Service Bulletin

01-076

Model 520 HVAC Recirculation Door

Figure 7

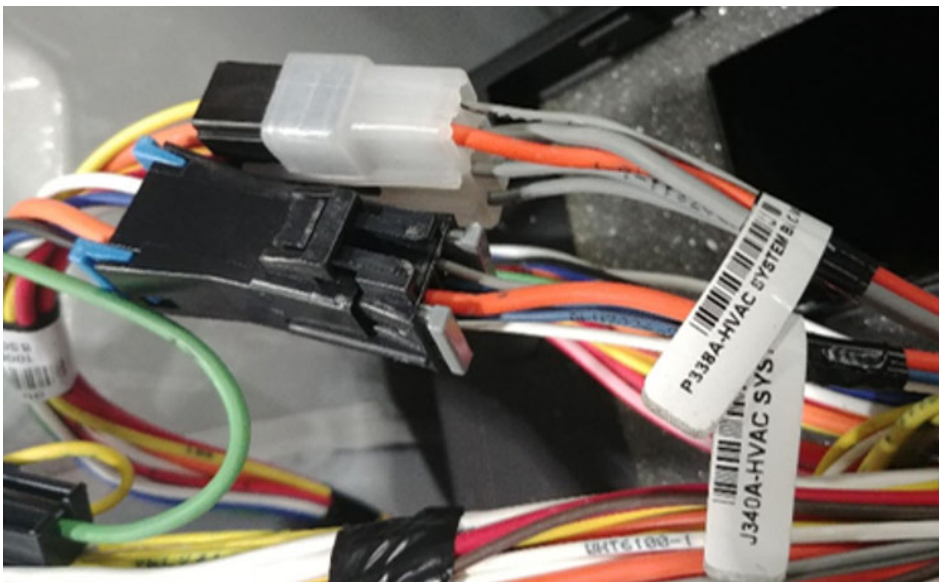
Peterbilt has determined that certain model 520 trucks manufactured between 6/20/2017 and 8/10/2018 with LH and RH Steer may have a Recirculation Air Blend Door that does not work properly. There is an additional circuit in the HVAC wiring that could cause the controls for recirculation mode and fresh air mode to operate opposite of their intended function.

7. The two connectors are on the passenger side at the back panel next to the fuse panel. The connections shown in Figure 7 are for Right Hand Steer.

1. Locate connectors J340A and P338A on the passenger side of the cab, above the HVAC main connection.
2. Remove wire GRA7223-3 from cavity "D" of connector J340A and seal the end of the wire with heat shrink tubing.
3. Remove wire GRA7223-1 from cavity "D" of connector P338A and seal the end of the wire with heat shrink tubing.

1. Locate connectors J340B and P338A on the passenger side of the cab, under the dash cluster and above the HVAC main connection.
2. Remove wire GRA7223-5 from cavity "D" of connector J340B and seal the end of the wire with heat shrink tubing.
3. Remove wire GRA7223-4 from cavity "D" of connector P338A and seal the end of the wire with heat shrink tubing.
